From: Alina Schiller
Sent: Wednesday, October 26, 2022 9:45 AM
To: NuScale-SDA-720DocsPEm Resource
Cc: Getachew Tesfaye
Subject: FW: Final Safety Evaluation for NuScale Licensing Topical Report TR-0915-17772, Revision 3, "Methodology for Establishing the Technical Basis for Plume Exposure Emergency Planning Zones at NuScale Small Modular Reactor Plant Sites"
Attachments: NuScale EPZ TR Final Safety Evaluation - Non-Prop Version Rev.pdf

SAFETY EVALUATION FOR NUSCALE TOPICAL REPORT, TR-0915-17772, REVISION 3, “METHODOLOGY FOR ESTABLISHING THE TECHNICAL BASIS FOR PLUME EXPOSURE EMERGENCY PLANNING ZONES AT NUSCALE SMALL MODULAR REACTOR PLANT SITES”

Figure 1: GMRS for the sites selected for the NRC staff's evaluation and NuScale's CSDRS

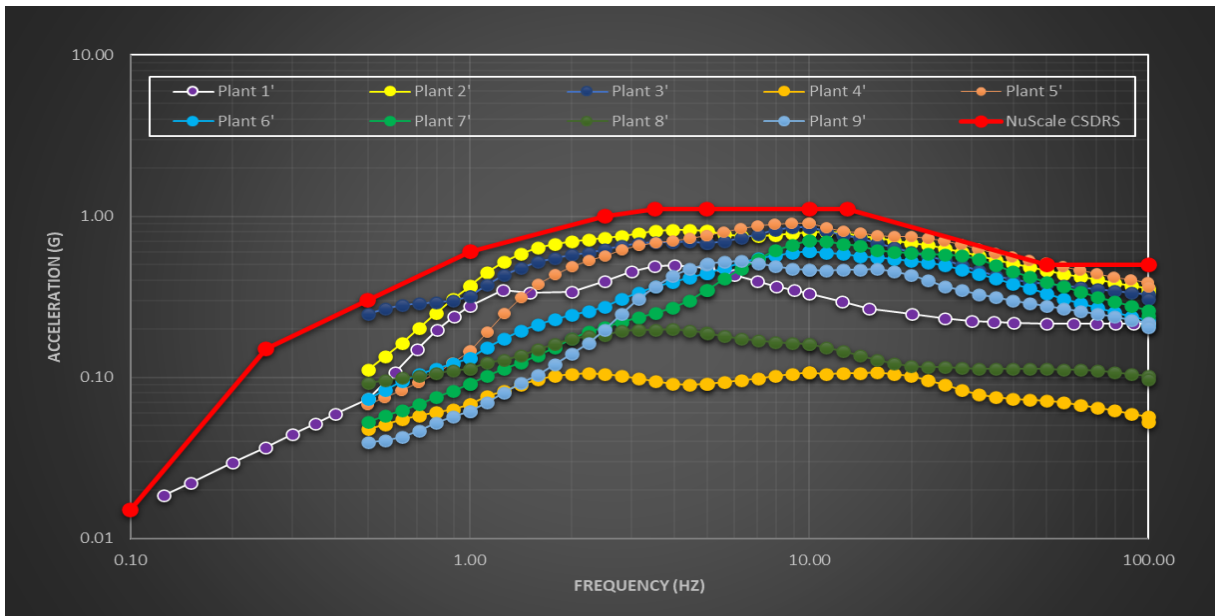
The NRC staff's evaluation determined the seismic risk that would be expected to be excluded from EPZ sizing considerations (the "risk gap") based on the {{ }} The NRC staff evaluated the size of the "risk gap" based on nine plant sites

within the NuScale Certified Seismic Design Response Spectrum (CSDRS). Specifically, the NRC staff evaluated the percentage and absolute value of seismic CDF that would be excluded from EPZ sizing. Consistent with NUREG-0396, the objective of the NRC staff's evaluation was to ensure that a seismic risk was captured for consequence analysis to: (1) include an adequate amount of seismic events in the spectrum of accidents for EPZ sizing, and (2) to include some of the key characteristics of large releases from seismic severe accidents. Further, as discussed above, WASH-1400 and by extension NUREG-0396 did not include quantitative seismic risk estimates in the dose-distance calculations. Due to these constraints, the seismic CDF was used in the NRC staff's evaluation of the adequacy of the {{
}}

Step 1: The NRC staff identified nine (9) operating reactor sites to provide a sufficiently large representation of seismic hazards across the contiguous US and collected the mean seismic hazard curves for these sites. The sites include the Western US (WUS) and the Central Eastern US (CEUS) with different site characteristics. The seismic hazard information used for each site includes the mean hazard curve at various spectral frequencies (e.g., 0.5 Hz, 1 Hz, 2.5 Hz, 5 Hz, 10 Hz, and 100 Hz) and the ground motion response spectrum (GMRS). The latest re-evaluated seismic hazard information was used for each selected site. The sites were selected such that the GMRS for each site was bounded by NuScale's CSDRS for the horizontal direction provided in Table 3.7.1-1 of the NuScale Final Safety Analysis Report (ML20224A484). Figure 1 shows the GMRS for the sites selected for this case study and the CSDRS. The GMRS was used to determine the spectral ratios representing the ratio of the acceleration at a particular frequency to the acceleration at peak ground acceleration (PGA; 100 Hz) (see ML100270582 for details on deriving spectral ratios). An example of the derived spectral ratios is provided in Table 2.

Step 2: The NRC staff used the NuScale high confidence of low probability of failure (HCLPF) plant level fragility (PLF) of 0.84g anchored to the PGA. This HCLPF PLF is based on the NuScale FSAR Section 19.1.5.1.2.

Step 3: The NRC staff convolved the hazard curves at different frequencies with the PLF to estimate the seismic CDF. The convolution of hazard curve and PLF is a well understood and widely used method of estimating the seismic CDF (e.g., see Results of Safety/Risk Assessment of Generic Issue 199, "Implications of Updated Probabilistic Seismic Hazard Estimates in Central and Eastern United States on Existing Plants" ADAMS Accession number

Based on its review and evaluation, the NRC staff determined the need for a "Condition of Use" that ensures the use of the {{ }} only if the HCLPF PLF is equal to or greater than 0.84g PGA. As stipulated in Section 5.0 of this SE (Condition E), the use of {{ }} in this TR is allowed only if the HCLPF PLF is equal to or greater than 0.84g at peak ground acceleration (100 Hertz). The HCLPF plant-level fragility will be the peak ground acceleration at the probability of 0.01 on the mean conditional core damage probability curve derived from a seismic PRA that meets the "Condition of Use" on PRA technical acceptability discussed above (Condition B in Section 5.0 of this SE).
